SUBJECT: Approval of Moon, Stevens, and Rugg Brook TMDLs

EPA NEW ENGLAND'S TMDL REVIEW

- TMDLs: Moon, Stevens and Rugg Brooks, Vermont
- **STATUS:** Final
- **DATE:** February 19th, 2009
- **IMPAIRMENT/POLLUTANT**: Biological impairment (aquatic life support) caused by stormwater-related stressors: the TMDLs are proposed for stormwater runoff volume as a surrogate for the pollutant sediment and a variety of other stressors associated with stormwater.

Figure 5. High flow portion of the flow duration curves for Moon Brook and attainment stream. _____ Moon Bk _____ Teney Brook

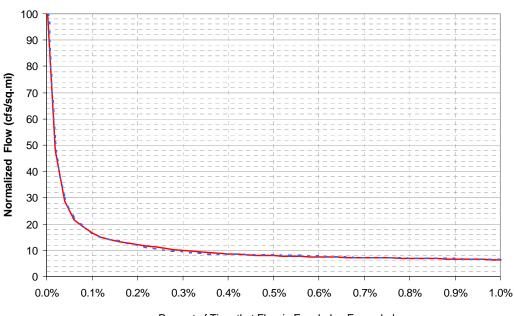
4. Page 14. The coincident of the graphs in Figure 5 does not seem to support a significant expenditure of resources to reduce stormwater related flows in Moon Brook. [Rutland]

<u>Response:</u> As noted in the TMDL, the high flow reduction target from current modeled conditions is 12%. Across the spectrum of the stormwater impaired streams for which TMDLs have been developed, this percent flow reduction is relatively modest. However, at this time watershed-specific implementation planning and cost estimates have not been developed to estimate the resources required to achieve this target.
